DSP56371E Digital Signal Processor

Mask 1L41N

Silicon Errata

Errata Number: ES140

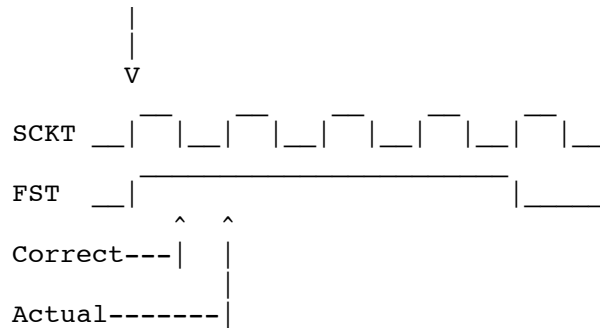
When providing an external word length FST and bit clock (SCKT) to the ESAI transmitter, the transmitter may lose the first bit if the SCKT clock trails the FST. It is important to maintain equal length signal paths for both the FST and SCKT clocks in slave mode.

FST and SCKT should be synchronous as shown by the arrow at the top of the following figure.

The correct time to latch the FST is on the falling edge when the clock polarity bit is clear. However, when SCKT trails FST it is actually being latched on the following rising edge as shown.

If the ESAI inputs the FST rising edge before the SCKT rising edge that generated it then it will "skip" a bit and assume the first bit has already been driven and start to output the second bit. The ESAI would be one bit ahead of the external device.

Workaround: The SCKT clock should be synchronous with the FST clock and should not trail it when the ESAI transmitter is in slave mode.
